## NOVI PLAZA FACADE JSP 15-40

Approval at the request of Scott Monchnik & Associates for revised Preliminary Site Plan and Section 9 Façade Waiver. The subject property is located in Section 26, South of Ten Mile Road and west of Meadowbrook Road, in the B-1, Local Business District. The subject property is approximately 1.6 acres and the applicant is proposing to remodel the existing façade for Novi plaza shopping center along with modifications to the existing parking lot.

**PLAN REVIEW CENTER REPORT**  
January 09, 2017  
**Planning Review: Preliminary Site Plan**  
Novi Plaza Facade  
JSP 15-40

**RIGHT SIDE ELEVATION**  
 1/4" = 1'-0"

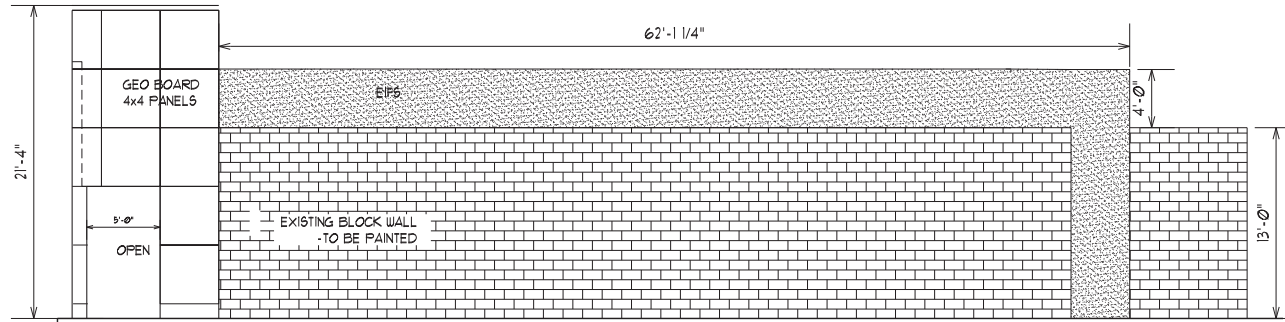
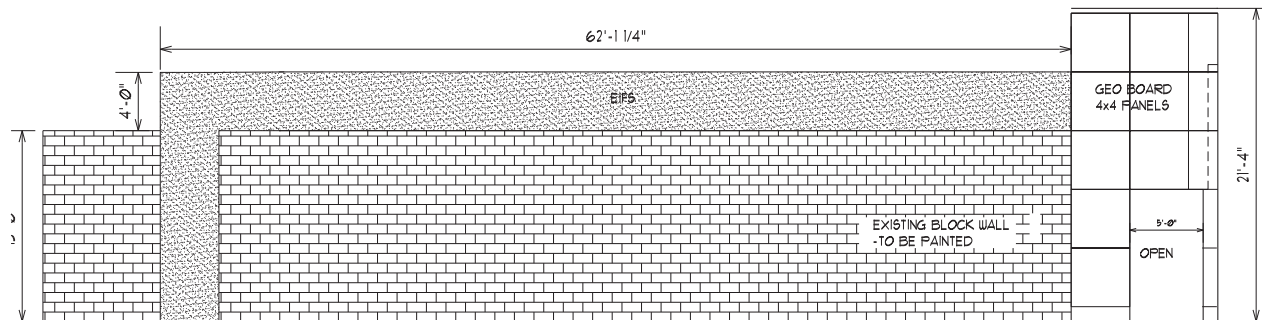
- a. To allow the underage of brick on all facades and overage of painted CMU on east and west facades (50% allowed, 65% provided), because the proposed alteration will significantly improve the overall appearance of the building and is consistent with the intent and purpose of the Façade Ordinance, which is hereby granted.
- b. The findings of compliance with Ordinance standards in the staff review letter and the conditions and the items listed in that letter being addressed.

This application is considered a façade alteration as regulated by Section 5.15.6 of the Ordinance. As shown above the minimum percentage of **Brick** is not provided on all facades and the amount of **Painted CMU** exceeds the maximum amount allowed by the Ordinance on the east, west and south facades. A section 9 Waiver would be required for these deviations.

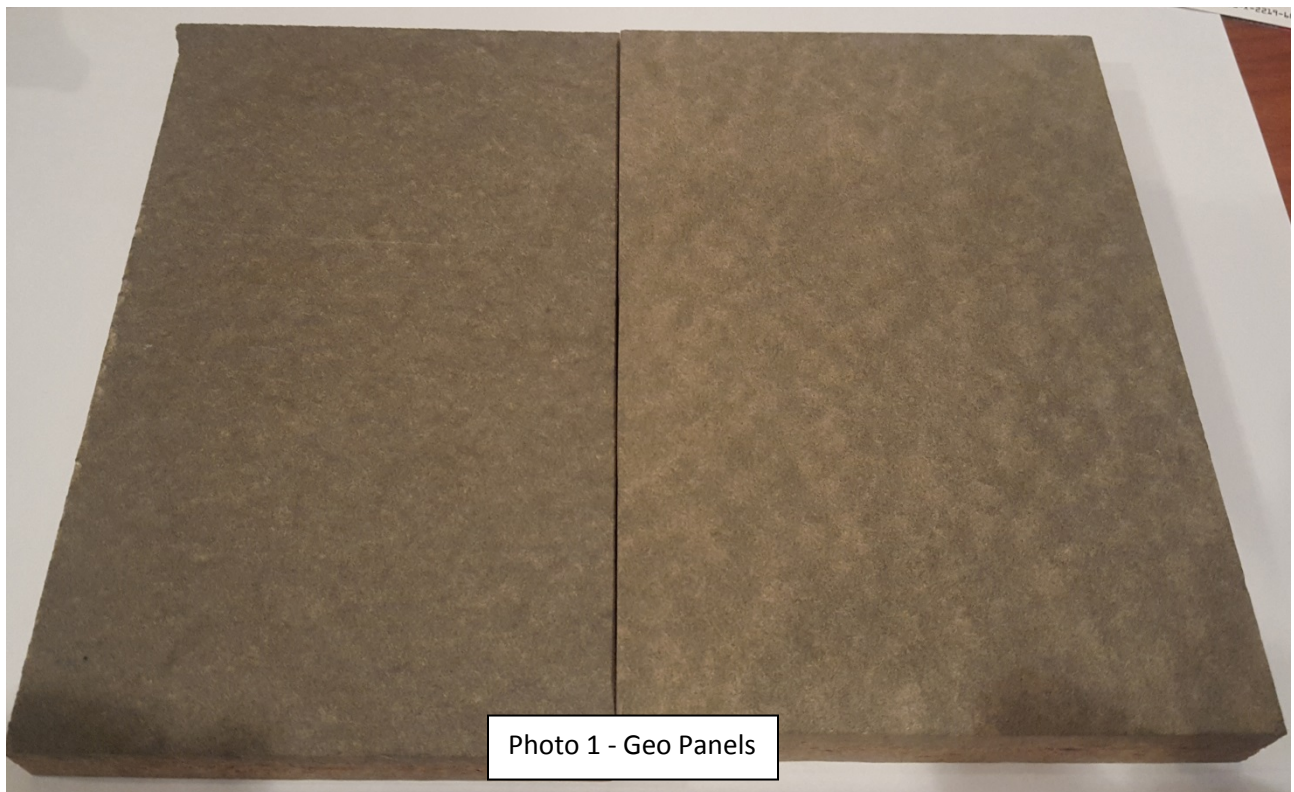
The following is the Façade Review for Preliminary Site Plan Approval of the above referenced project. This review is based on the drawings prepared by Scott Monchnik & Associates Architects, dated 12/6/16. The percentages of materials proposed for each façade are as shown below. Materials that are not in compliance with the Ordinance Section 5.15, if any, are shown on bold. The façade material sample board required by Section 5.15.4.D of the Ordinance was not provided at the time of this review.

North (Front)	East	West	South	Façade Ordinance Section 2520 Maximum (Minimum)
Brick	<b>19%</b>	0%	0%	N/A	100% (30% Min.)
"Geo Panels" (Treated as GFRC)	16%	13%	13%	N/A	25%
Spandrel Glass	16%	0%	0%	N/A	50%
Cultured Stone	25%	0%	0%	N/A	50%
Painted CMU (existing, to be repainted)	0%	<b>65%</b>	<b>65%</b>	N/A	50%
EIFS	24%	22%	22%	N/A	25%

The proposed design includes the extension of the buildings parapets from 4' to 12' above the existing roof line on the front (north) façade and 4' above the existing roof line on the east and west facades. This will screen the extensive amount of unsightly roof-top equipment existing on the building and significantly improve the overall appearance of the building as viewed from 10-Mile Road. Drawings of the south elevation were not provided. The lower portion of south façade is substantially screen by an existing decorative fence and evergreen plantings. However, the roof-top equipment is visible on the south façade, albeit to a lesser degree that the other facades. The applicant should therefore consider adding screening of the roof top equipment on the south façade. The areas of CMU on the east and west facades represent existing materials that are incorporated into the overall design in an aesthetic manner.

The “Geo Board 4 x 4 Panels” material has been treated as Glass Fiber Reinforced Concrete (GFRC) for this review as this material has similar visual properties. A photograph of this material was provided by the applicant (Photo 1). The applicant has indicated that the “Cultured Stone” will be as manufactured by Stone Works 43” x 8” x 1 3/4” panels, or equal (Photo 2).

**Recommendation** – For the reasons stated above it is our recommendation that the proposed design is consistent with the intent and purpose of the Façade Ordinance and that a Section 9 Waiver be granted for the underage of Brick and overage of Painted CMU. Our recommendation is contingent upon the applicant providing the sample board clarifying the exact type and color of all proposed façade materials not less than 5 days prior to the Planning Commission meeting. Also, revised drawings should be provided coordinating the façade changes recently proposed by the restaurant user located at the east end of the center under a separate application.
